THE INFAMOUS C100

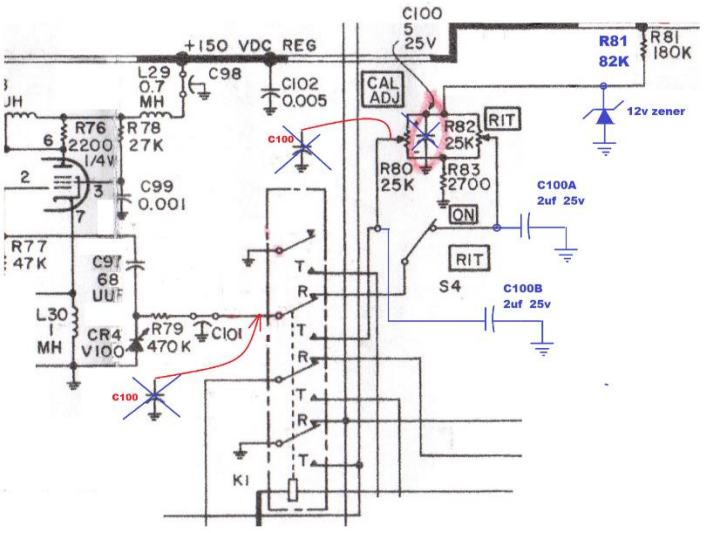
The infamous C100, It migrates all around the RIT circuit. Hallicrafters could not decide where they wanted to put it. It did not work connected to the tie-point of R81 and R80. It can be located at C101. Sometimes it is on the wiper of R80 the RIT control. Sometimes it is on the wiper of R82. RED IN DRAWING BELOW

PROBLEM: In its original placement, high V side of CAL and RIT pots to gnd, it did not eliminate the stray pick up by wiring running from the front panel to the relay and on to the VFO. Placing it on the wire connecting the relay to C101 works great on SSB. But if operating CW, break-in keying, with the RIT turned on, the first dit or dash has a chirp.

The reason they wanted it in there was to decouple the line that feeds the VFO diode CR4. The wires run all over under the chassis and pick up a lot of noise, which would cause FMing of the VFO.

I have found the best solution is a zener diode mod to the RIT circuit and splitting C100 between R80 and R82. BLUE IN DRAWING BELOW

Adding a zener diode at the junction of R80 and R82 provides a stable reference voltage for the bias divider. More importantly, the zener establishes an extremely low impedance to gnd for any ac or rf induced into the wiring. The zener mod is in the sr-150 repair manual on https://wd0gof.com . Look for section 3-3-2.
